CITY OF ALBUQUERQUE

April 22, 2016

**RE: Lot 41, Block 6 Volcano Cliffs Unit 18
6639 Sueto Rd NW
Grading and Drainage Plan
Engineer's Stamp Date 4-20-16 (D10D003M41)**

ENGINEER'S SEAL 4/20/16	LOT 41, BLOCK 6, UNIT 18 VOLCANO CLIFFS SUBDIVISION	DRAWN BY JDG
	GRADING AND DRAINAGE PLAN	DATE 04-21-2016
 1606 CENTRAL AVENUE SE SUITE 201 ALBUQUERQUE, NM 87106 (505) 872-0999		SHEET # 1 OF 1
		JOB #

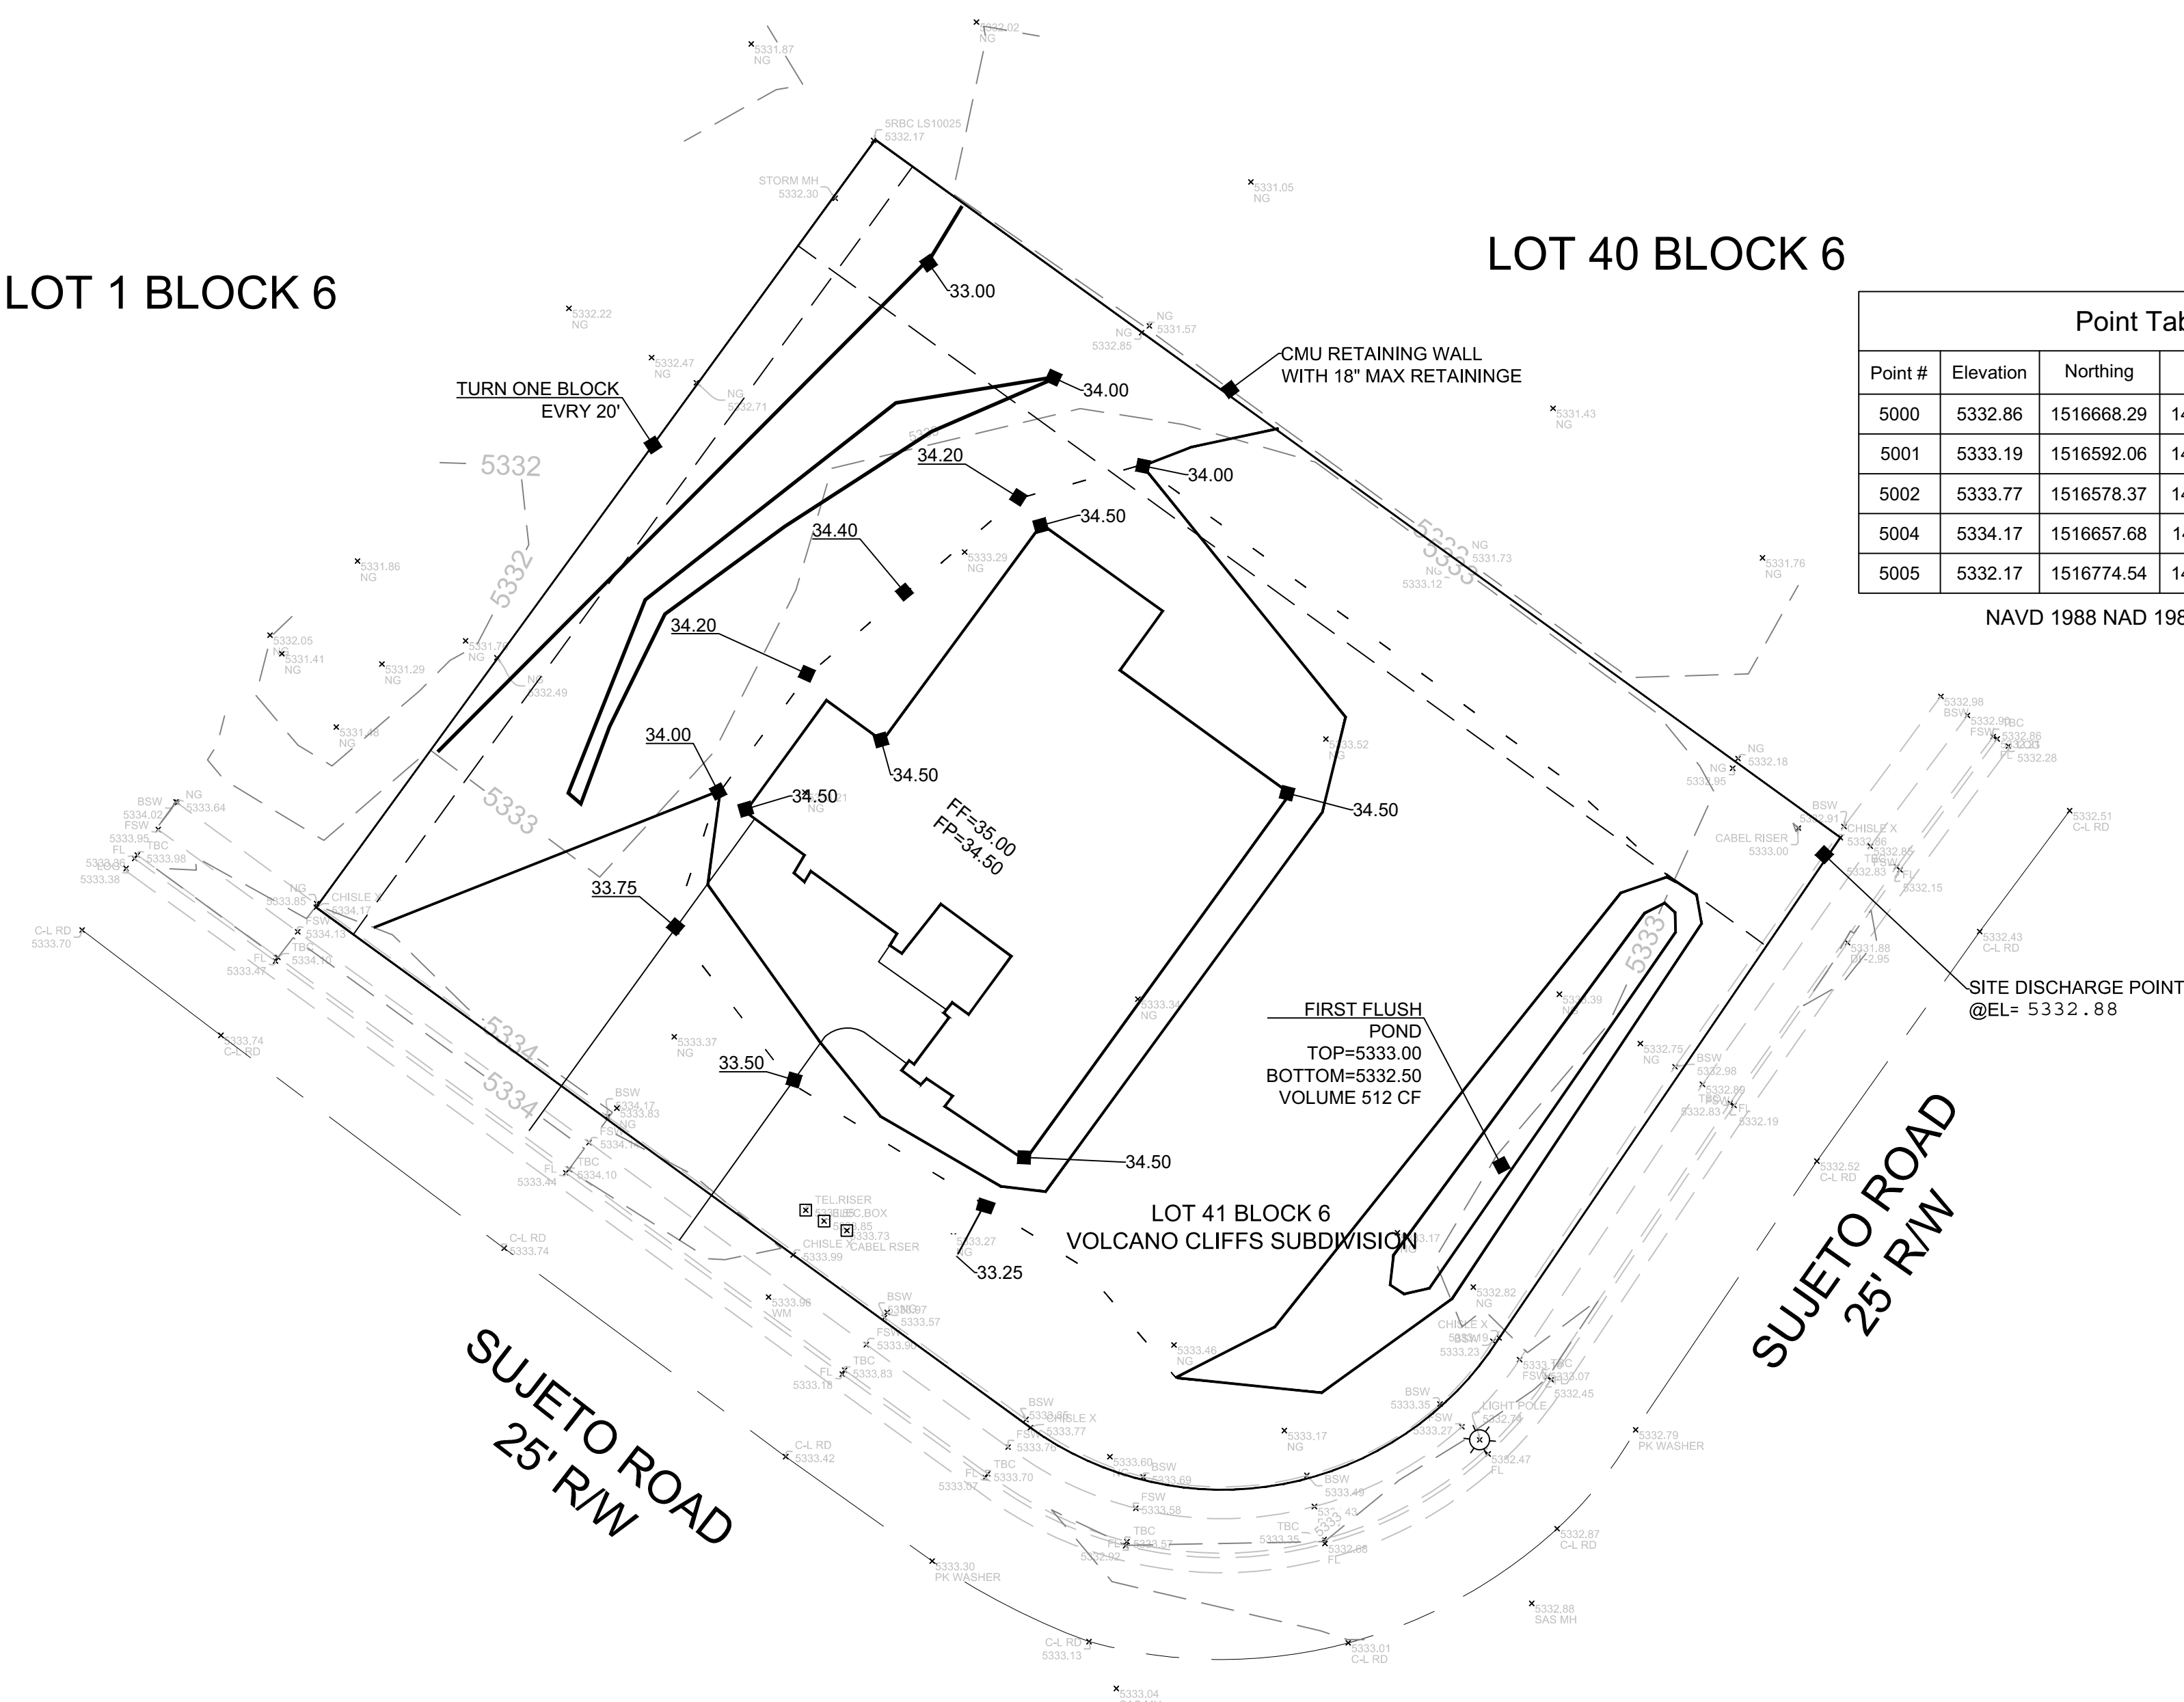
PO Box 1293
Based upon the information provided in your submittal received 4/21/16, this plan is approved for Grading Permit and Building Permit.

Albuquerque
Please attach a copy of this approved plan to the construction sets in the permitting process prior to sign-off by Hydrology. A separate permit for the wall is required. Attach this approved plan to the wall permit set. Place all turn blocks 3" above grade for sediment control and landscaping.

New Mexico 87103
Prior to Certificate of Occupancy release, Engineer Certification per the DPM checklist will be required.
